Re: Chapel Hill Police Station Coal Ash Dump Site (ID # NONCD0001486) – Additional Comments on Phase II Remedial Investigation Report

Re: Response to SELC Comments
Phase II Remedial Investigation Report
Police Department Property
828 Martin Luther King, Jr. Blvd.
Chapel Hill, NC
H&H Job No. TCH-002

Flood Plain Map

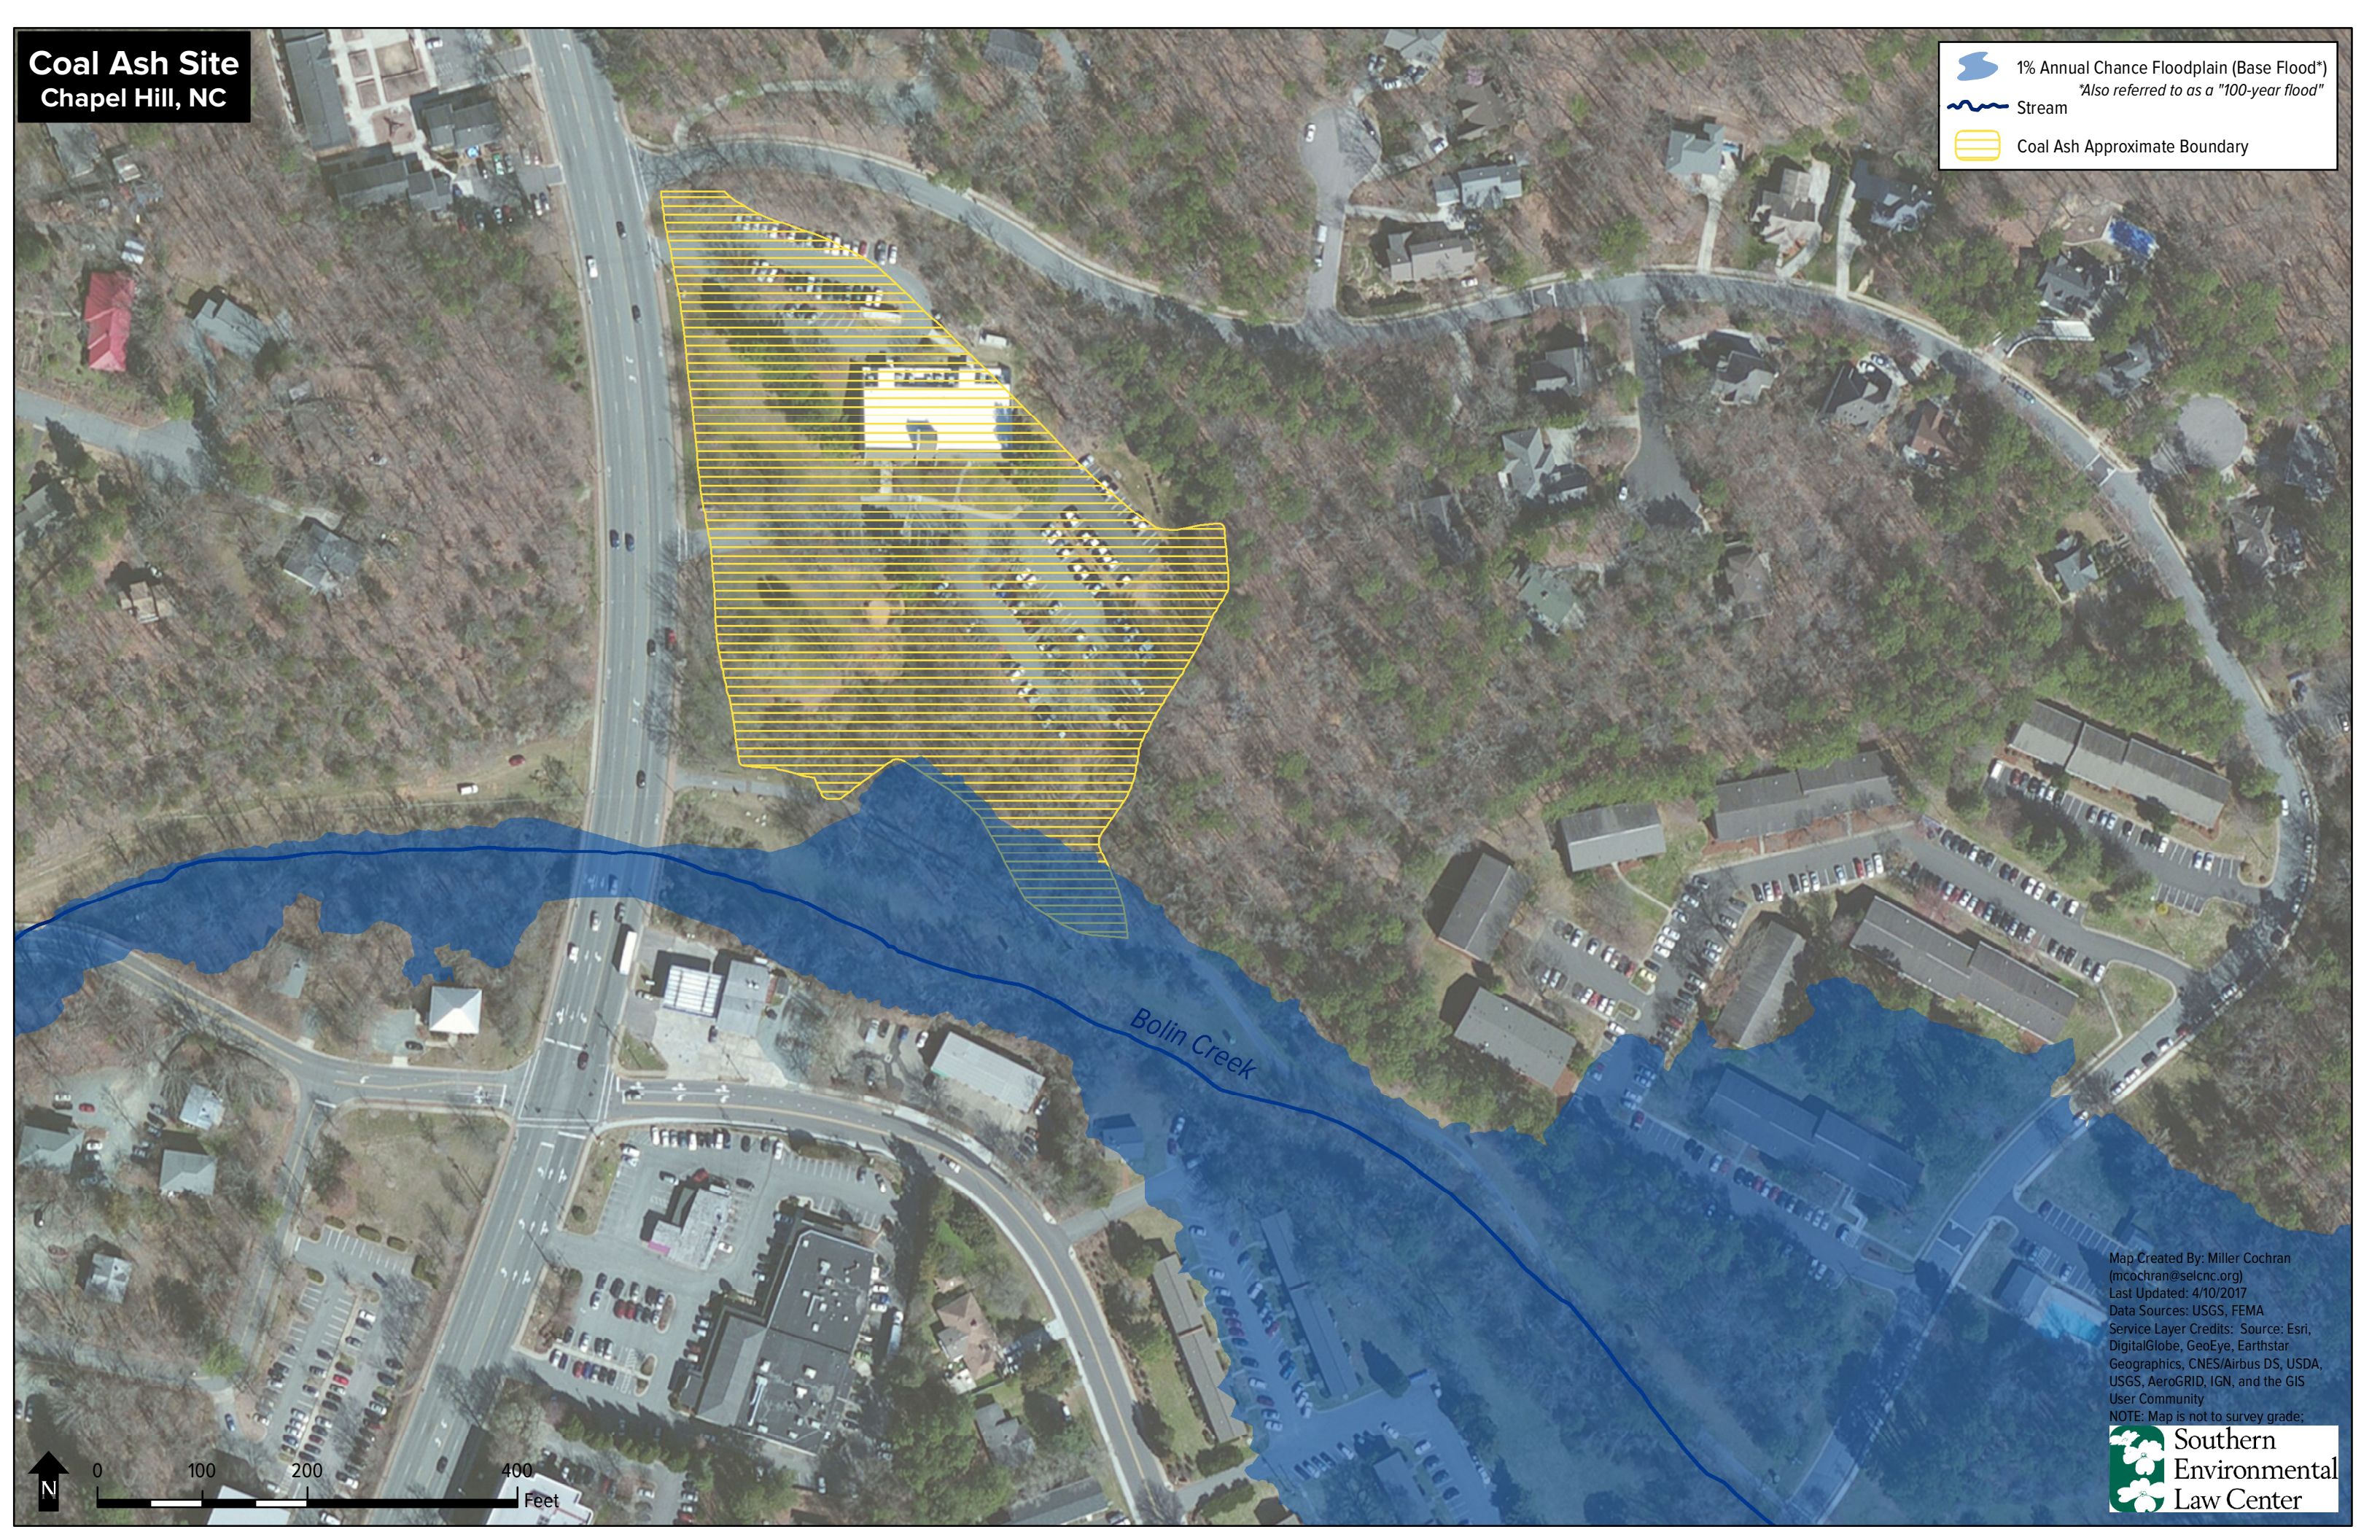
The coal ash at the Site extends into the floodplain of Bolin Creek. A map showing the approximate location of the coal ash deposit in relation to the 100-year floodplain of Bolin Creek is attached to this letter as Attachment 1. Coal ash and toxic pollutants from the site that are located within the floodplain are likely to be washed downstream when the creek floods.

In addition, elevated flood waters could cause erosion at the base of the 40-foot high coal ash cliff area near the public greenway, further decreasing its structural stability. This situation presents an additional long-term risk to the public and natural resources of Bolin Creek, and is yet another reason why the coal ash cannot be left in place. Instead, it must be removed to safe, dry, lined storage away from public waters.

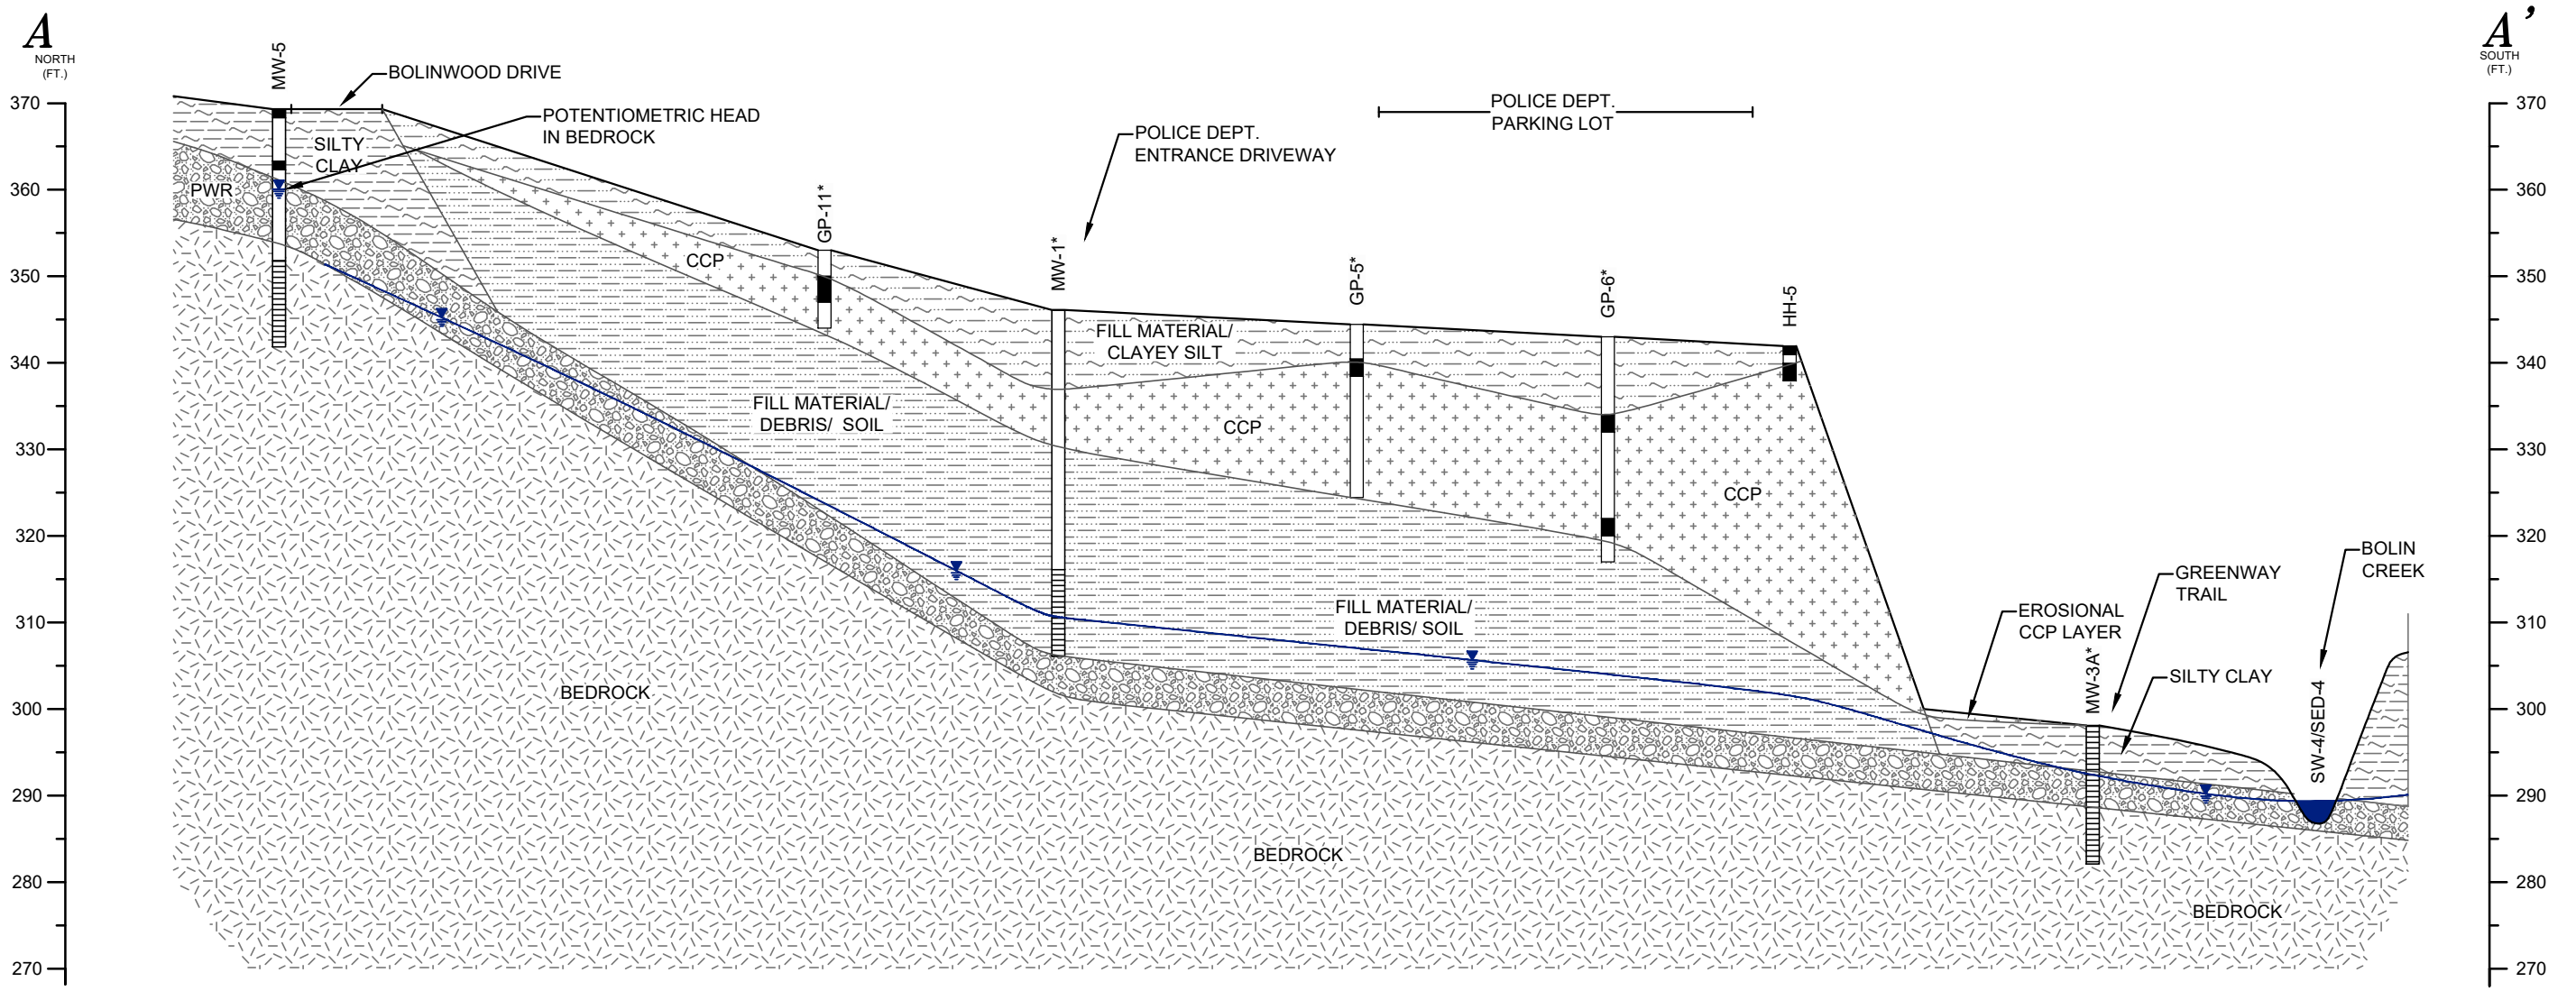
As we pointed out in our initial comments, the Report claims that the ash is separated from the groundwater (*see* Report Fig. 5), but this claim appears to be contradicted by earlier data gathered at the site. Specifically, the well drilling log for MW-1 indicates that a thicker layer of ash extends below the water table. Chapel Hill's response to these concerns states that "[t]he 2013 Well Construction Record is prepared by a driller and is not a geologist's or

- **There is also a serious discrepancy in the report.** The report claims the coal ash is separated from the groundwater. For example, figure 5 of the report shows a thin layer of ash at monitoring well MW-1 that is some 20 feet above the groundwater. However, the original well drilling log for MW-1 shows that the coal ash extends down ten feet *below* the water table, and that the layer of coal ash is 31 feet thick. *See* 2013 Well Construction Record, attached. This directly contradicts what is shown in the current report (fig. 5 is attached for reference). The Town must determine the true depth of the coal ash relative to the groundwater in order to understand the risks from ongoing pollution in this location.

There is also a serious discrepancy in the report. The report claims the coal ash is separated from the groundwater. For example, figure 5 of the report shows a thin layer of ash at monitoring well MW-1 that is some 20 feet above the groundwater. However, the original well drilling log for MW-1 shows that the coal ash extends down ten feet *below* the water table, and that the layer of coal ash is 31 feet thick. *See* 2013 Well Construction Record, attached. This directly contradicts what is shown in the current report (fig. 5 is attached for reference). The Town must determine the true depth of the coal ash relative to the groundwater in order to understand the risks from ongoing pollution in this location.

The 2013 Well Construction Record is prepared by a driller and is not a geologist's or engineer's boring log. Although the driller's Well Construction Record is generally considered accurate with regard to well construction details (which is the purpose of the record), the log of the soil and rock materials encountered is generally not considered accurate for use in environmental investigations, particularly where the work is overseen by a geologist or engineer, as is the case with the Phase I and II RI activities. The depth to and thickness of the CCPs at the site, including boring MW-1, was estimated from Table 5 of the March 25, 2014 Falcon Engineering Environmental Site Characterization Report, which is attached to this letter, and borings advanced by H&H as part of the Phase II RI. The closest boring to MW-1 is GP-1 which contained CCPs at depths of 9-12 ft (3 ft thick) (see Table 5). Other borings in the vicinity of MW-1 include GP-2, GP-3, and GP-5 which contained CCPs at depths ranging from 5-30 ft, 10-16 ft, and 4-8 ft, respectively (see Table 5). As indicated in Table 5 attached, the thickness of CCPs in the borings which encountered CCPs in the elevated portions of the site ranged from 3 to 25 ft with an

approximate average of 8 ft. Therefore, the depth and thickness of CCPs reported in the driller's Well Construction Record for MW-1 is not consistent with the data provided by Falcon Engineering's geologists and engineers, which we consider to be more reliable and accurate. Depth to water in MW-1 is approximately 35 ft below ground surface and the deepest that CCPs were reported by Falcon Engineering is 30 ft, with most CCPs present at depths less than 16 ft below ground surface. Therefore, as noted in our Phase II RI Report, we conclude that CCPs are not present below the water table.
